RE: **Montgomery Carwash**
3525 Montgomery NE
Grading Plan Stamp Date: 10/31/18
Hydrology File: F16D053

Based on the submittal received on 11/1/18, the Grading and Drainage Plan cannot be approved until the following are corrected:

ENGINEER'S SEAL DAVID SOULE NEW MEXICO REGISTERED PROFESSIONAL ENGINEER 14522 10/31/18	TRACT G-2-A-2 MONTGOMERY COMPLEX GRADING AND DRAINAGE PLAN Rio Grande Engineering 1606 CENTRAL AVENUE SE SUITE 201 ALBUQUERQUE, NM 87106 (505) 872-0999	DRAWN BY JDG DATE 10-31-2018 SHEET # 1 OF 1 JOB #
---	--	--

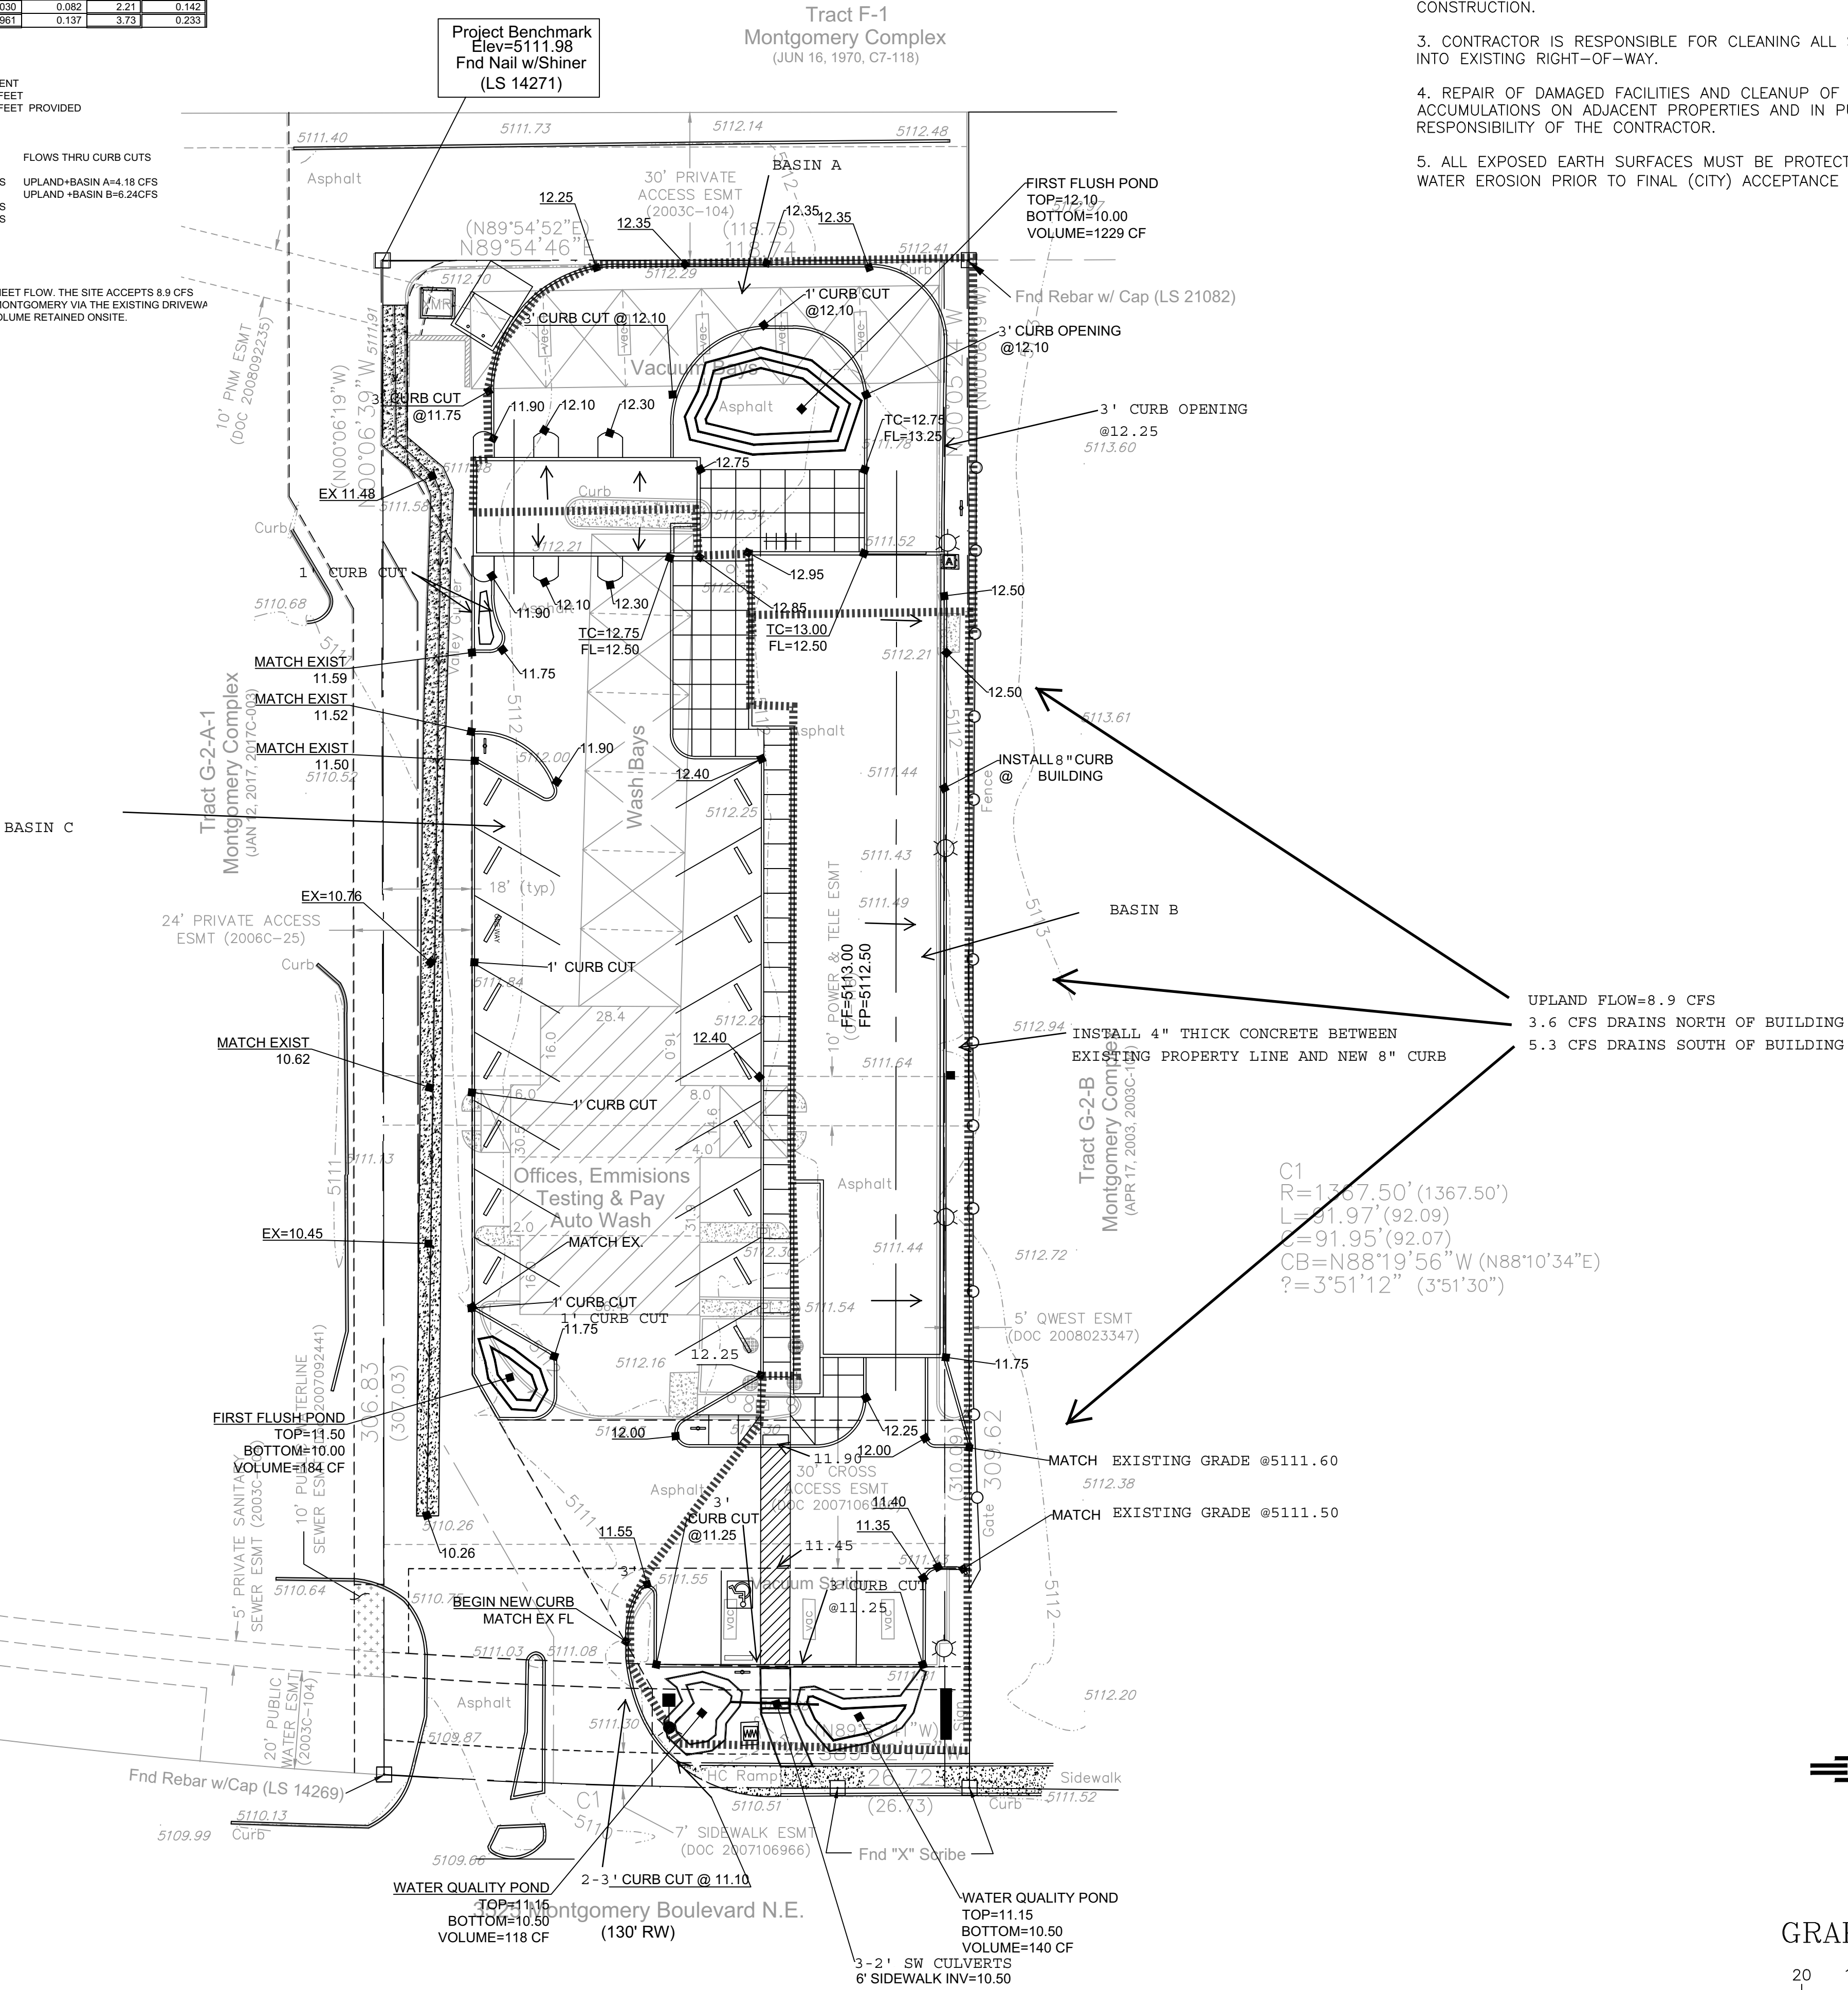
1. Basin C delineation needs to be shown on the plan. It is unclear how any of Basin C makes it to a stormwater quality pond.

2. Provide management onsite for the entire Stormwater Quality Volume in accordance with the new drainage ordinance, § 14-5-2-6 (H) enacted 10/2/18 (Council Bill C/S O-18-2). This site qualifies as redevelopment and is only required to manage runoff from the 80th percentile storm ($\text{Vol.} = 0.26'' \times \text{Imp. Area}$).

3. Each stormwater quality pond need to be sized for the area draining to it. These areas need to be clearly delineated and shown on the plan, or as a separate exhibit.

4. Provide a section through the building and east property line. How will the channel manage the roof runoff and the offsite flows? Please show the channel in plan view.
